FB23-0162 (245 Roble Ave) Job Copy

MK	DATE	BY	REVISION
1	9.8.23	GV	REVISED PER PLAN CHECK COMMENTS
2			
3			
4			
5			
6

DUPLEX @ ROBLE AVE 245 ROBLE AVE - REDWOOD CITY, CA FP1-COVER / RISER/HANGER DETAILS PLAN		SYSTEM NFPA 130 OCCUPANCY R DRAWN SV
 CONTROL FIRE <small>AN EXHAUSTING CORPORATION</small>	CONTROL FIRE, Inc. 50 Woodside Plaza, #214 Redwood City, CA 94061 PH (650) 268-9928 FAX (650) 649-1797 C-16 #1015580	
	DATE 08/11/2023 PROJECT NO. 328-20 FP1 OF 2

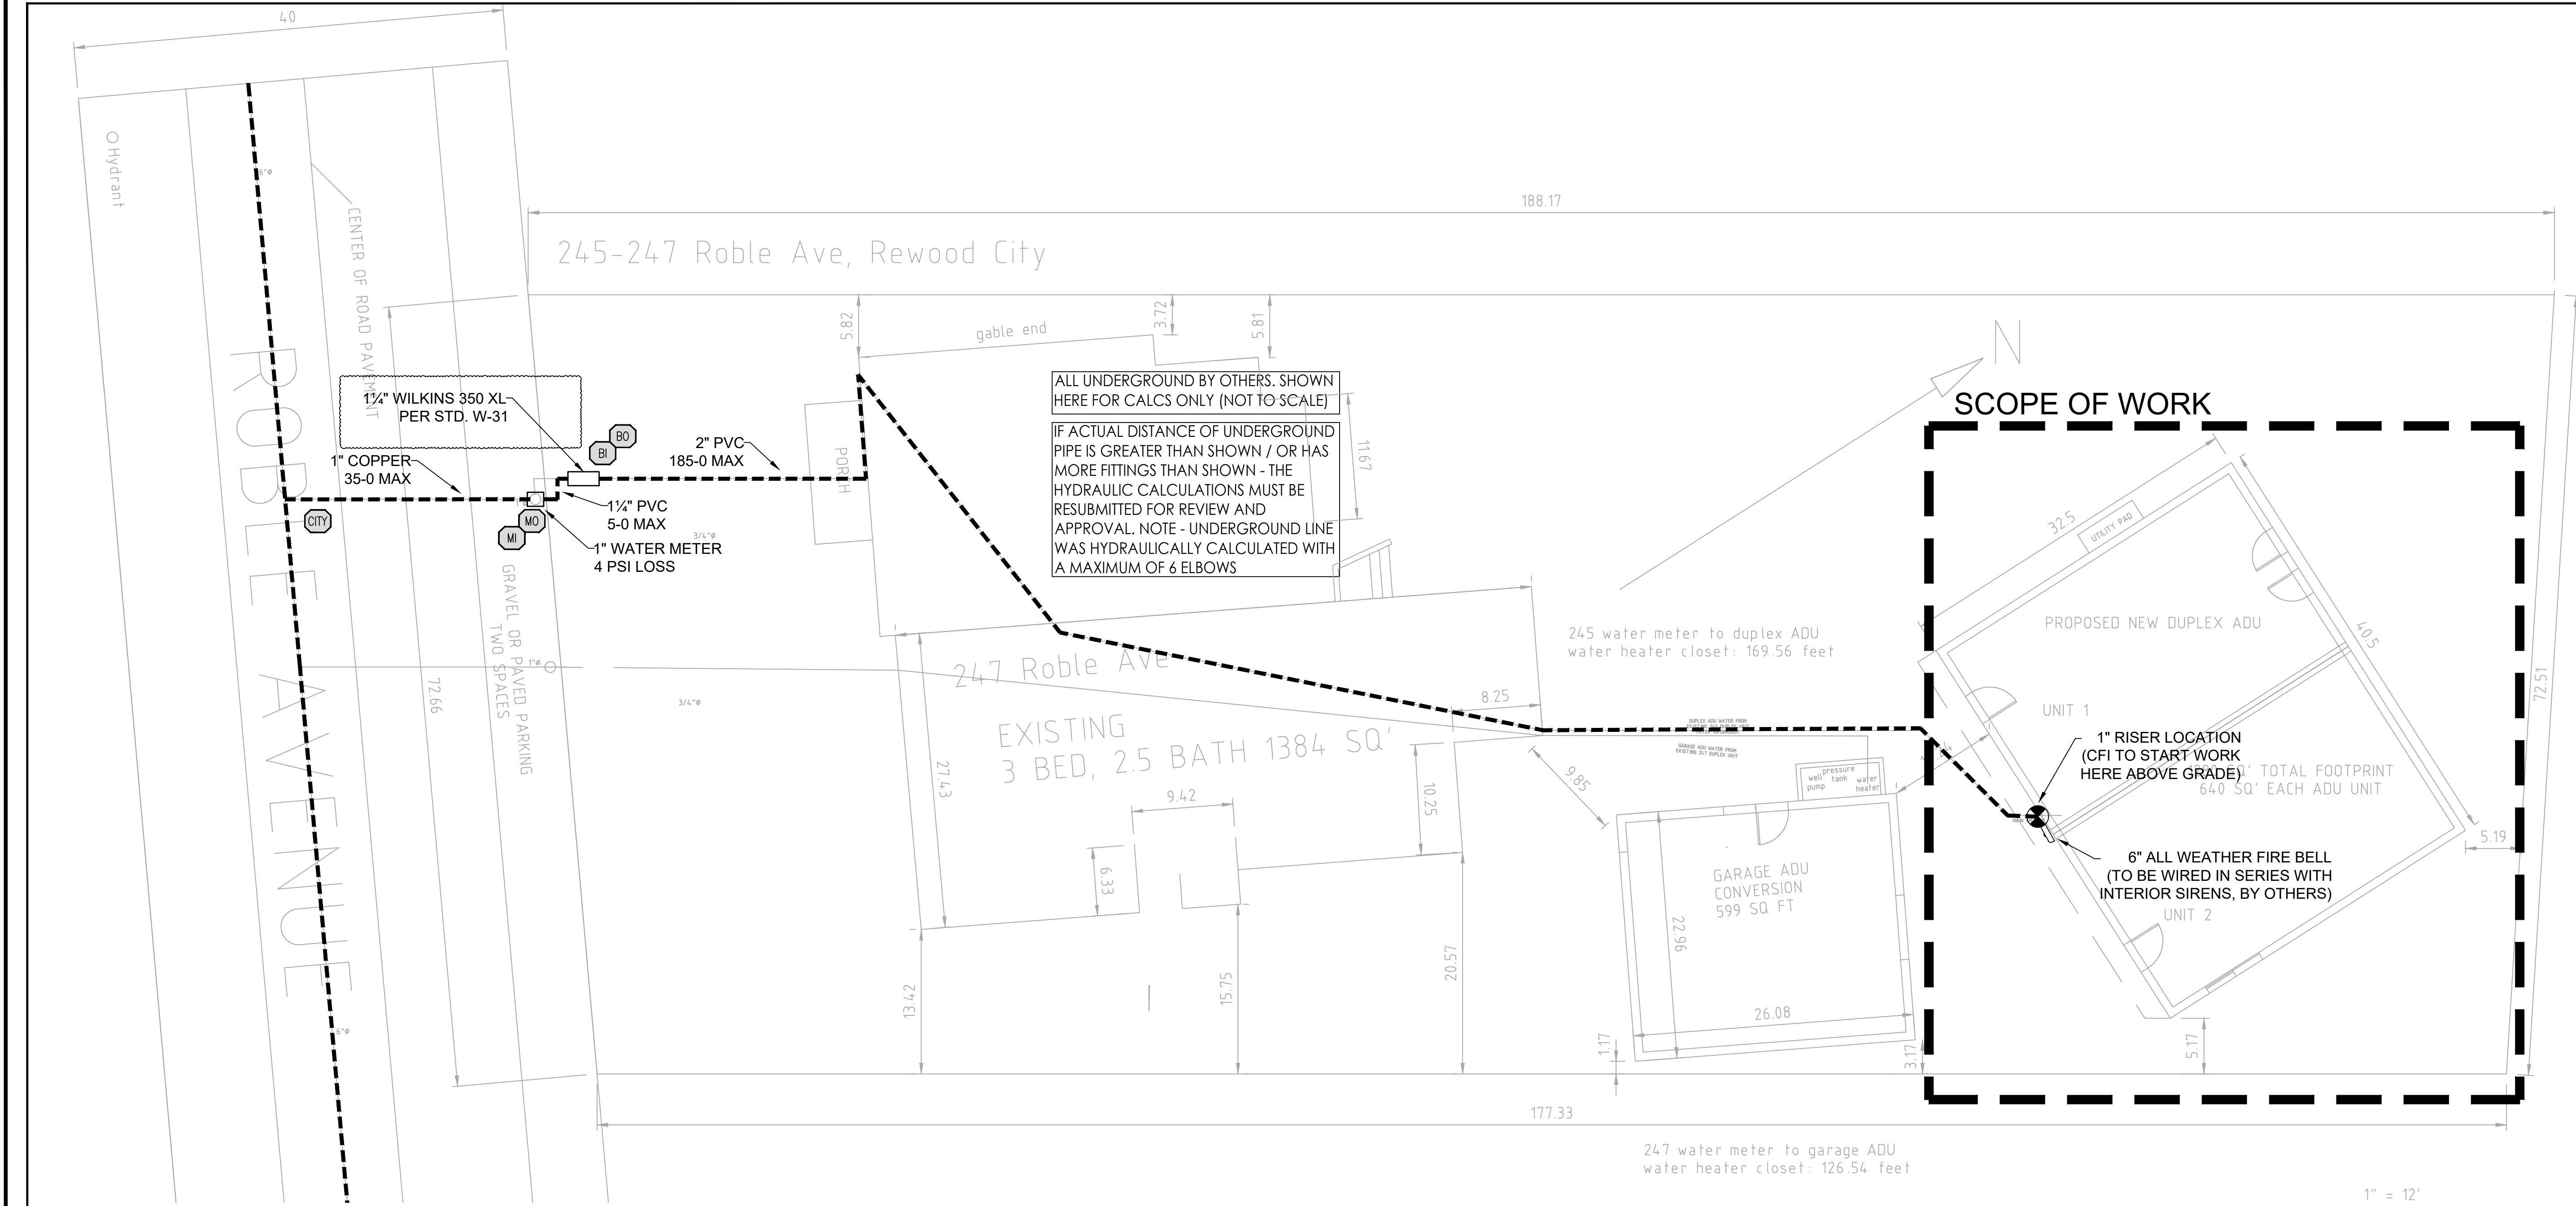
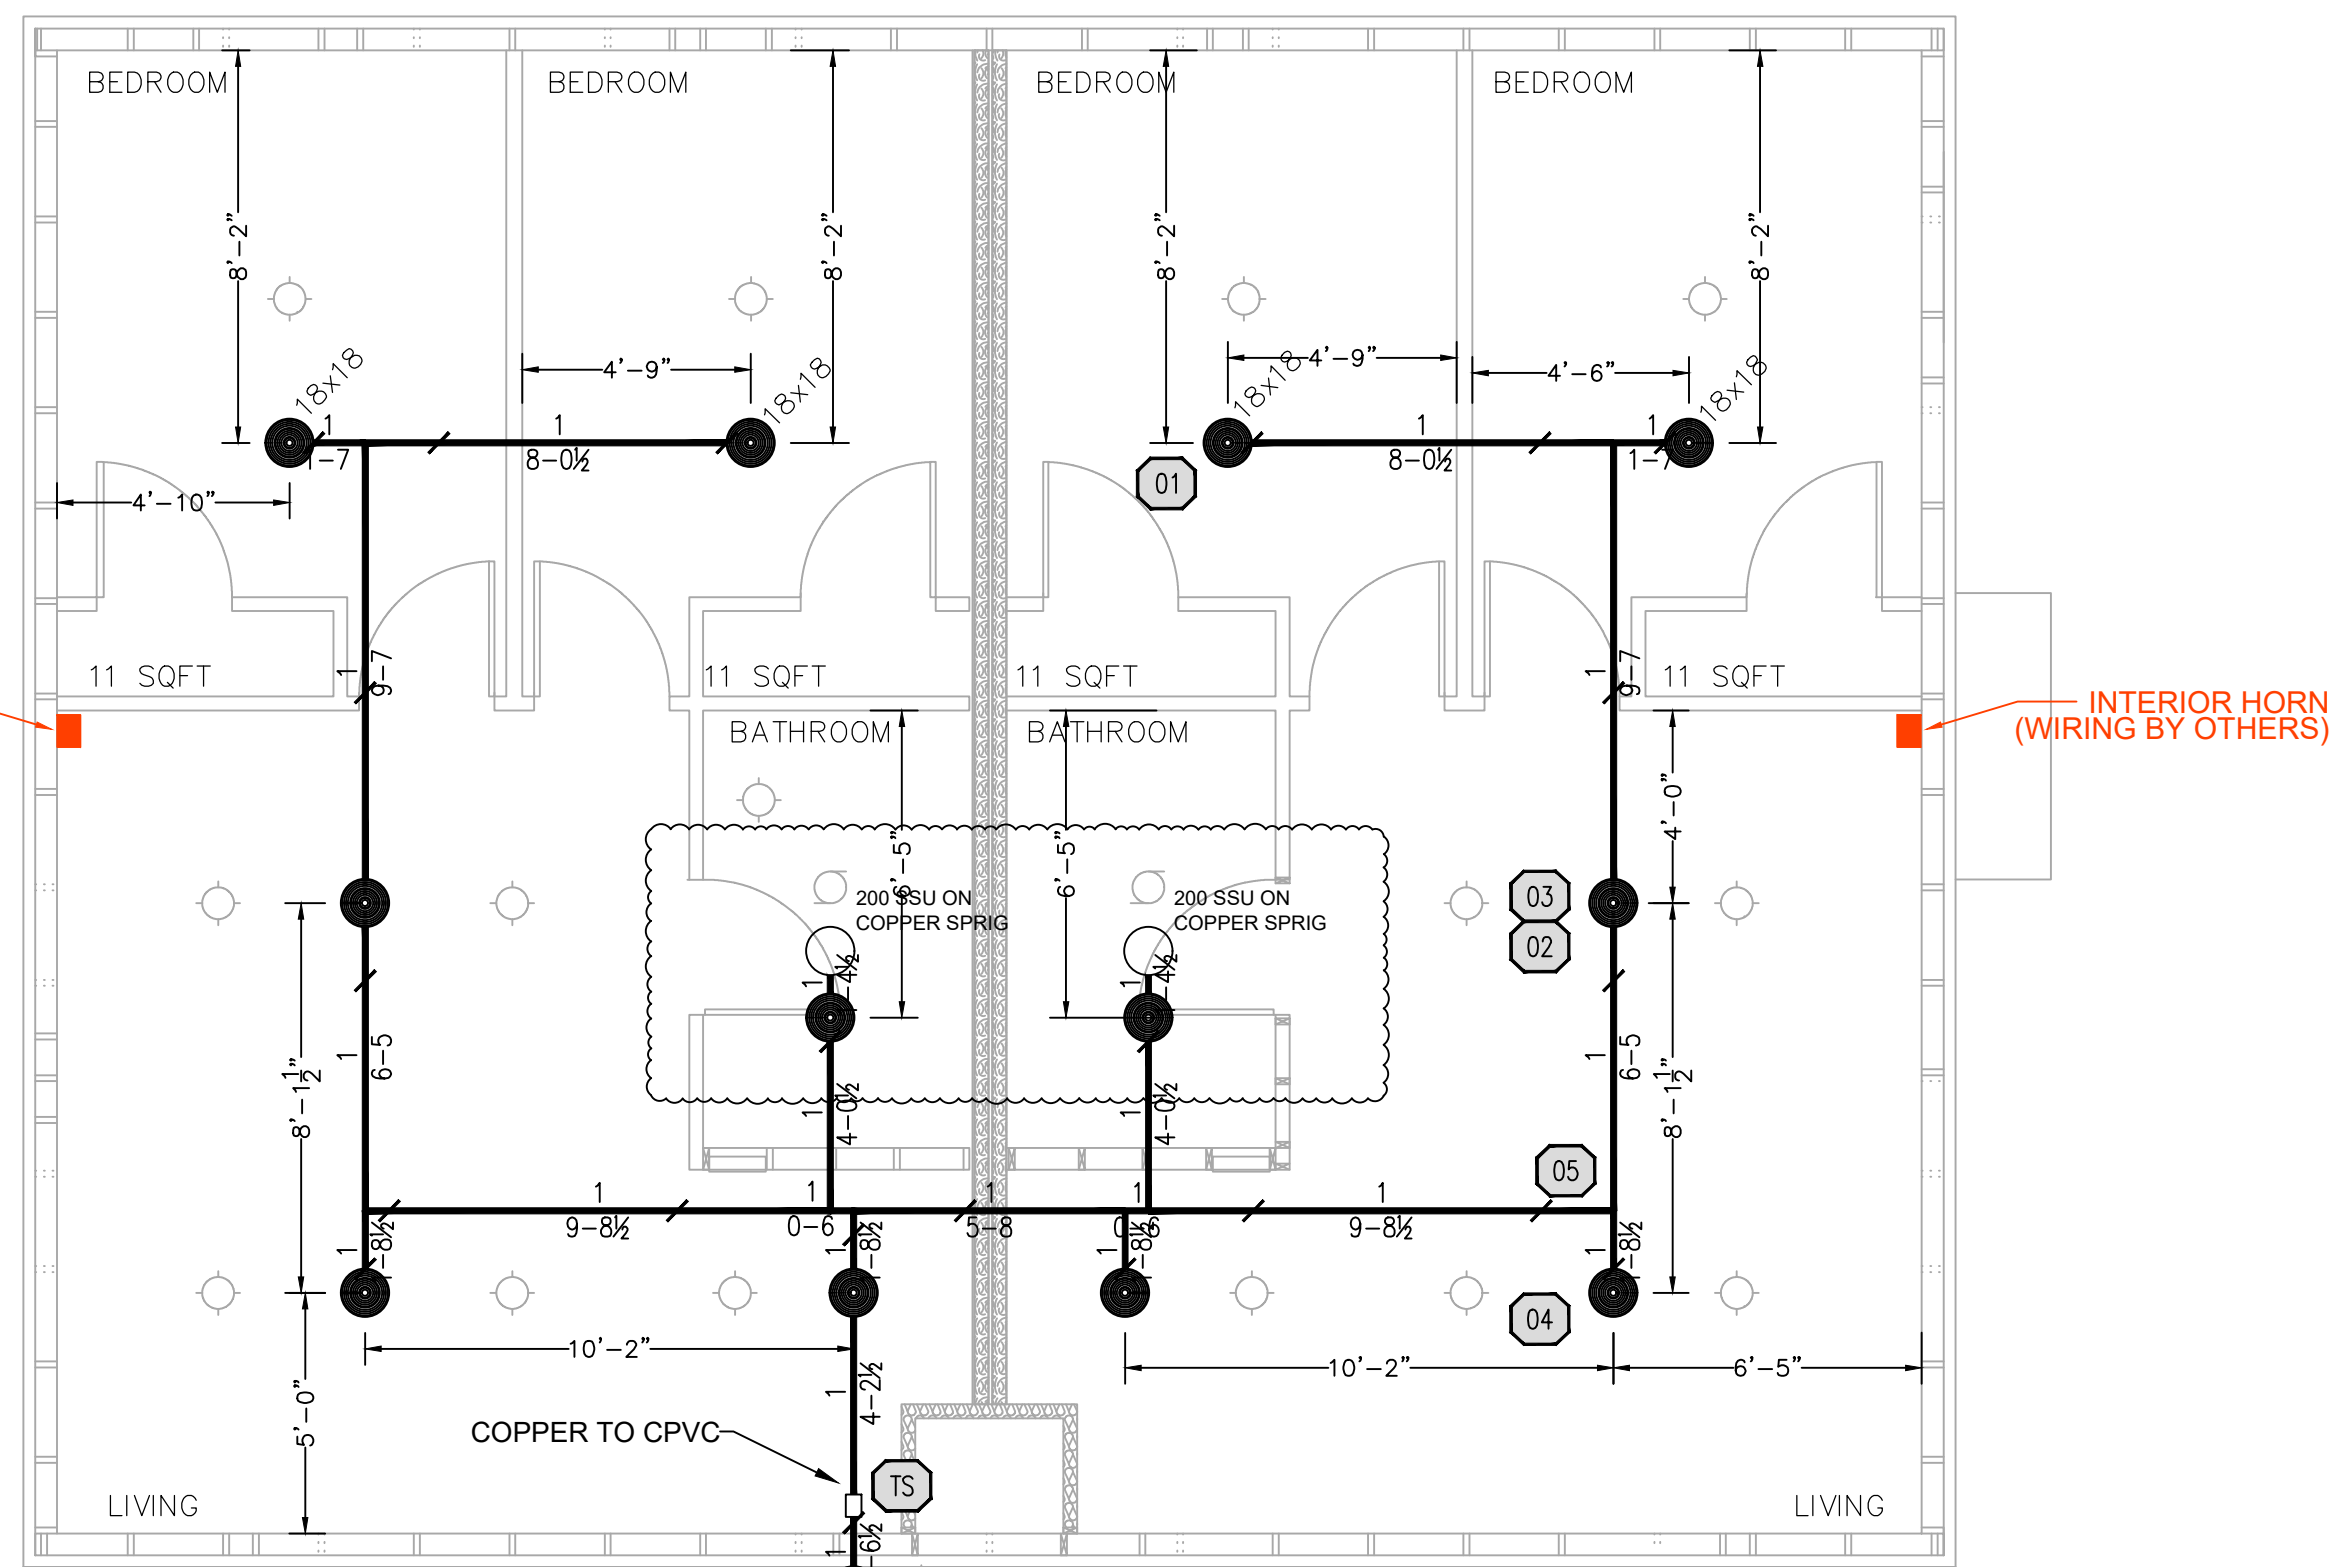
C.F.I TO ADD PILOT SPRINKLERS AT ALL ATTIC'S USED FOR STORAGE OR CONTAINING MECH. EQUIPMENT.
